**SUBJECT:** NuScale Power, LLC Response to NRC Request for Additional Information No. 205 (eRAI No. 9044) on the NuScale Design Certification Application

NuScale Response to NRC Request for Additional Information eRAI No. 9044

**eRAI No.:** 9044

**Figure 9.3.4-1: Chemical and Volume Control System Diagram**  
 (Chemical and Volume Control System Module 1 with Module Heatup System Subsystem 6A Shown)

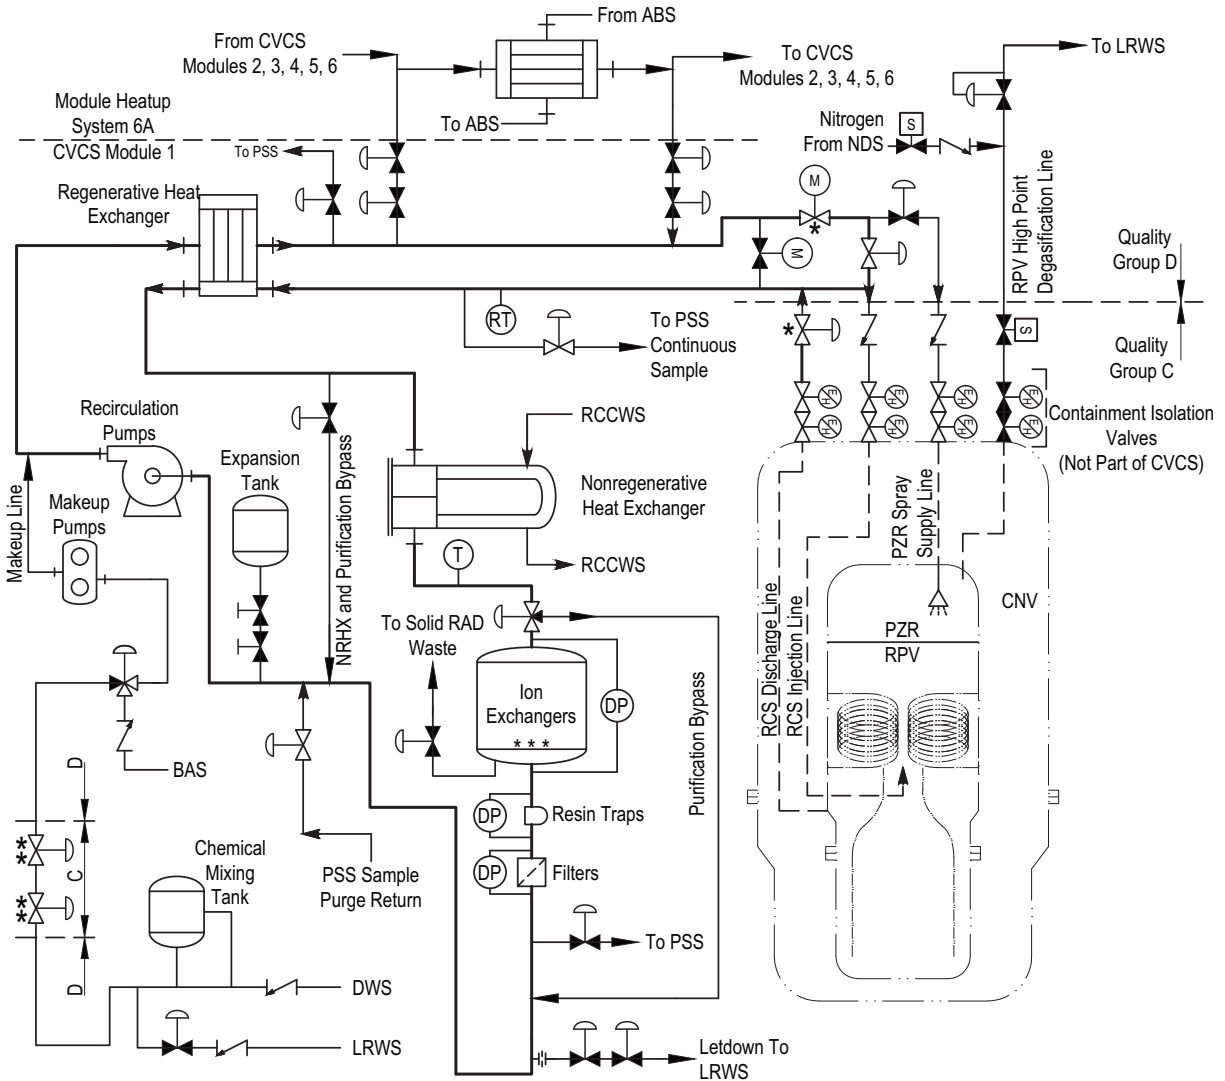
that the compressed air system (in addition to the nitrogen gas system) can provide gas to the Containment Evacuation System. It is unclear if this is where the nitrogen is being supplied from or if it is being supplied from elsewhere and how the design is adequate to ensure that nitrogen will push RCS fluid through the CVCS system and sampling line to the sampling point.

1. Please provide information sufficient to determine the source of the nitrogen and ensure that the pressure is sufficient to push the RCS fluid to the sampling point. As part of the response, provide information on minimum water levels in the reactor following design basis accidents, the CVCS system piping connection heights, and nitrogen injection point(s). Update the DCD to discuss how nitrogen injection is adequate to perform this task.

- b. Please describe in appropriate detail how the design prevents backflow into the instrument air system or how any backflow will not result in additional exposure to workers or additional release beyond what is accounted for in the accident analysis.

The instrument air system (IAS), depicted on FSAR Figure 9.3.1-1, supplies compressed air to operate pneumatically controlled valves and instrumentation in the NDS. The IAS does not supply nitrogen to the CNV to pressurize the containment for post-accident liquid RCS sampling, or supply compressed air directly to the containment evacuation system (CES) to pressurize containment. The IAS supplies compressed air to the service air system (SAS). The SAS is used to supply compressed air to the CNV through the reactor building (RXB) supply line to the CES to support draining the CNV prior to startup and to equalize CNV pressure with the refueling pool prior to unbolting the containment flange for disassembly. Backflow from the CNV to the compressed air system is controlled through the use of check valves in the SAS supply to the RXB and in the IAS supply to the SAS. Nitrogen backflow from RCS to the NDS is controlled using a check

valve on the nitrogen injection line to the RPV degasification line of the CVCS as shown on the updated FSAR Figure 9.3.4-1.

Revisions to FSAR Section 9.3.2.2.3 and FSAR Figure 9.3.4-1 in response to this RAI question are included with the response to RAI question 9.3.2-8.

Figure 9.3.6-2: Containment Flooding and Drain System Diagram

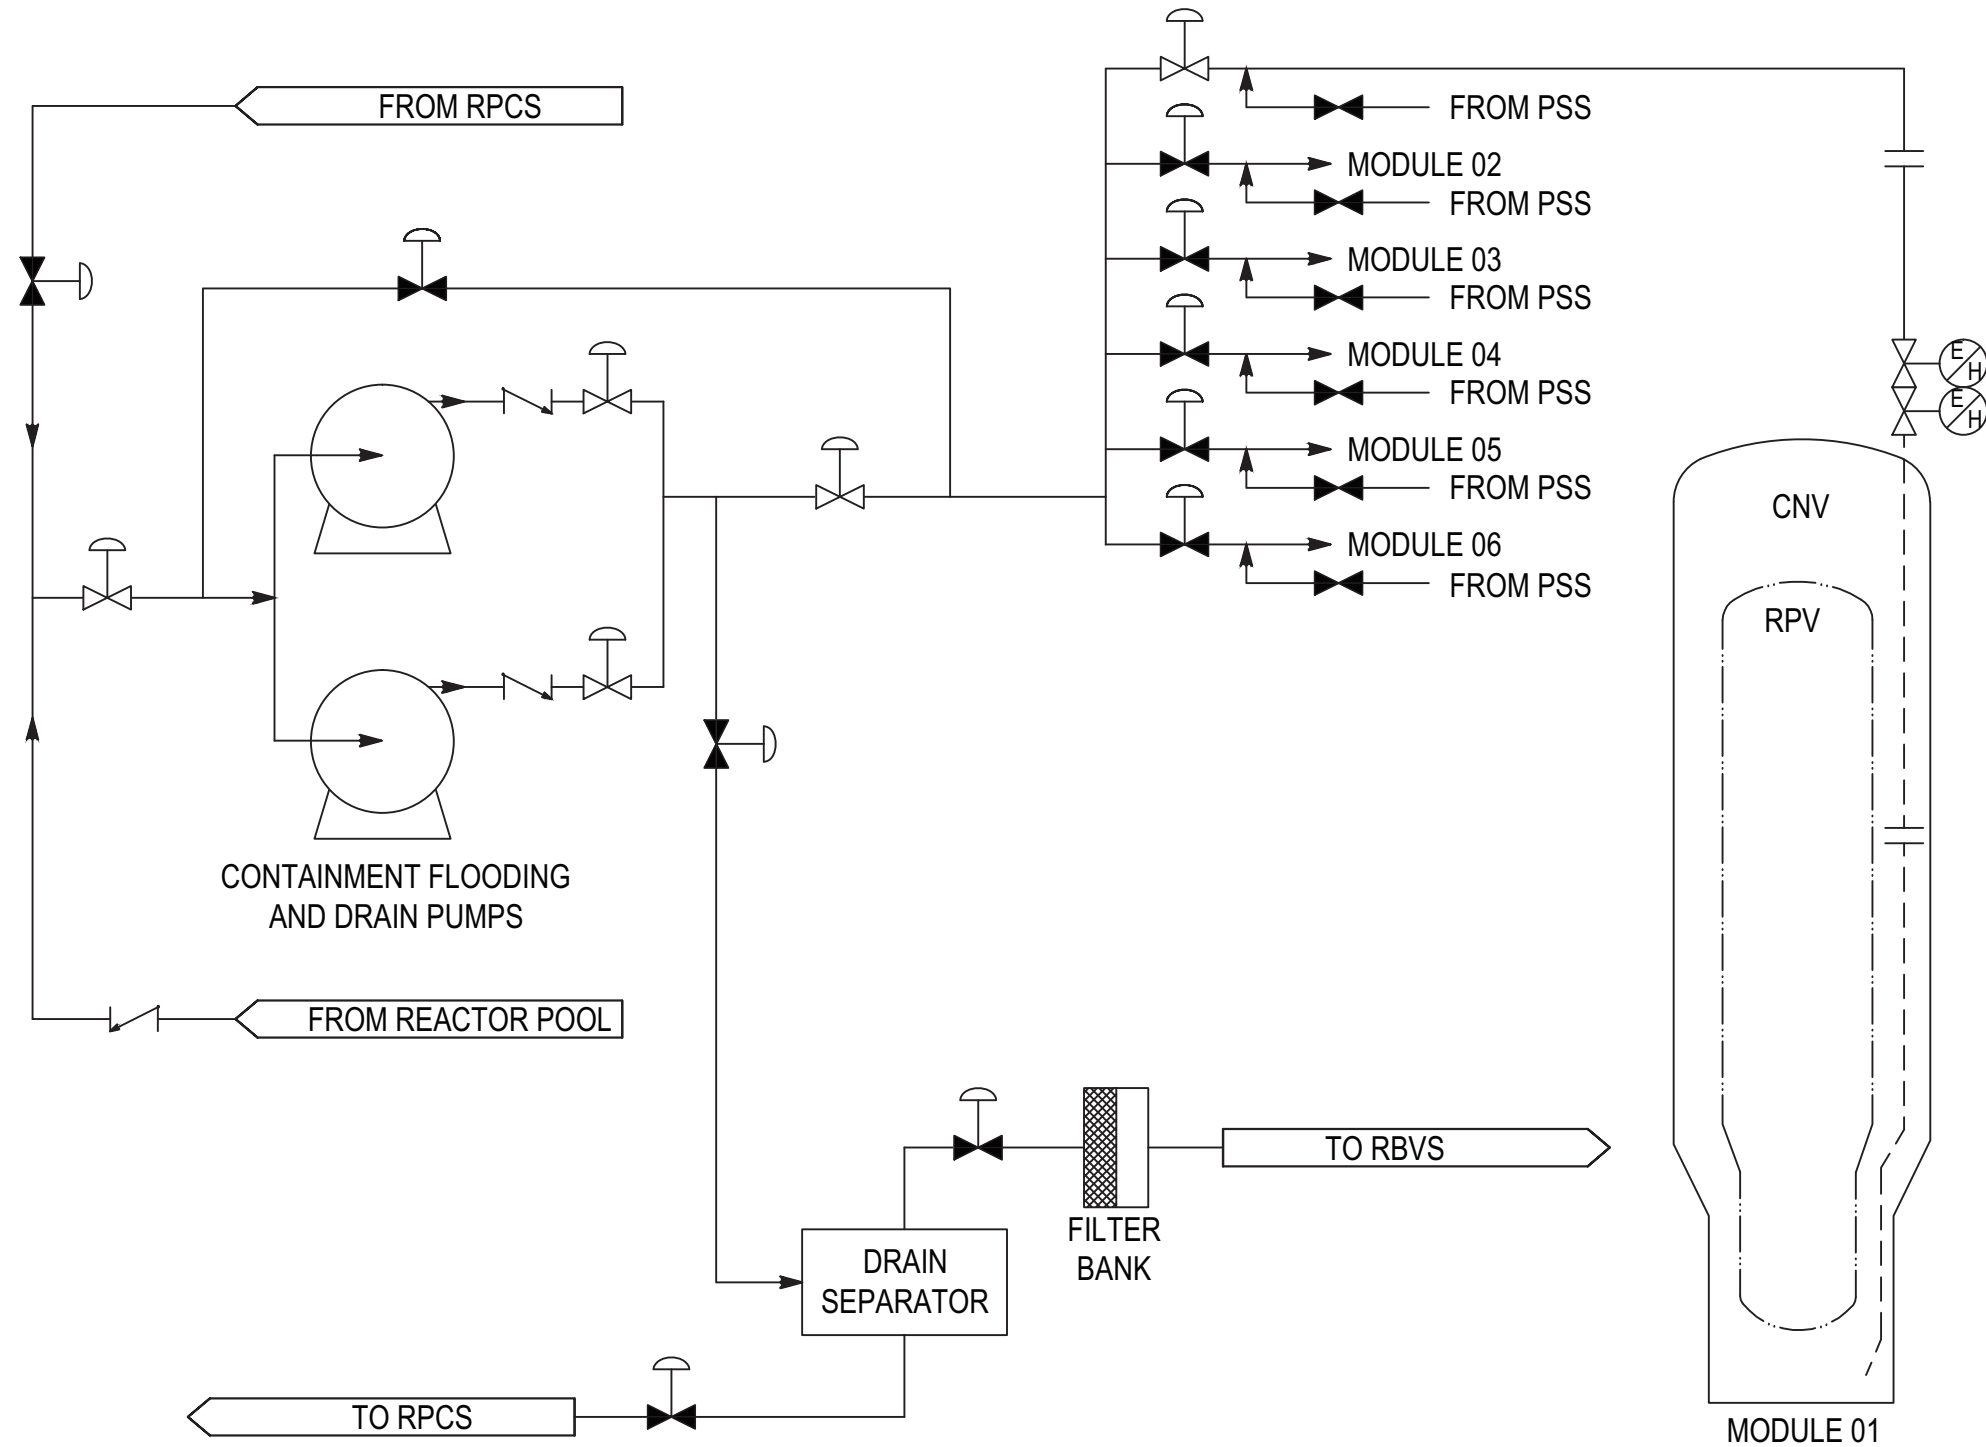
2. It is unclear which valves are required to be opened to take gaseous samples (only the CES or both the CES and CFDS?). Please clarify which valves need to be opened. If both CES and CFDS valves need to be opened to take gaseous samples, please clarify why the isolation valves for the CFDS (which goes to a part of the containment vessel that is expected to be submerged following an accident), needs to be opened to obtain a gas sample. Update the DCD as appropriate.

3. Likewise, it is unclear if the systems are appropriately designed to handle the temperatures and pressures that will be present. DCD Section 9.3.6, “Containment Evacuation System and Containment Flooding and Drain System,” does not specify the design limitations of the system. It is not clear if any relief valves are provided and at what pressure such relief valves would actuate (a significant release into the Reactor Building could occur, even if the piping were still intact, if a relief valve lifted, or a seal was damaged by heat). Please clarify the design limitations of the CES and CFDS systems and if the CES and CFDS systems downstream of the containment isolation valves are capable of withstanding the temperatures and pressures present 2 hours after an accident or if approximately 24 hours and less than 200 degrees Fahrenheit is required to open these valves. Update the DCD as appropriate.

the CFDS provides the optimal return path for the gas discharged from the containment sampling system sample pump to the CNV. Therefore, opening of CFDS CIVs is required for returning the gas back to the containment. Returning the containment gas sample back to the CNV limits potential radioactive release outside of the containment. FSAR Figure 9.3.6-2 has been revised to show the PSS sample return line connection to the CFDS before the respective module isolation valve.

FSAR Sections 9.3.2.2.3 and 9.3.2.5 and FSAR Figure 9.3.6-2 have been revised to clarify the post-accident sampling process and equipment required to support sampling. The FSAR changes referred to in this RAI are included with the response to RAI 9.3.2-8.
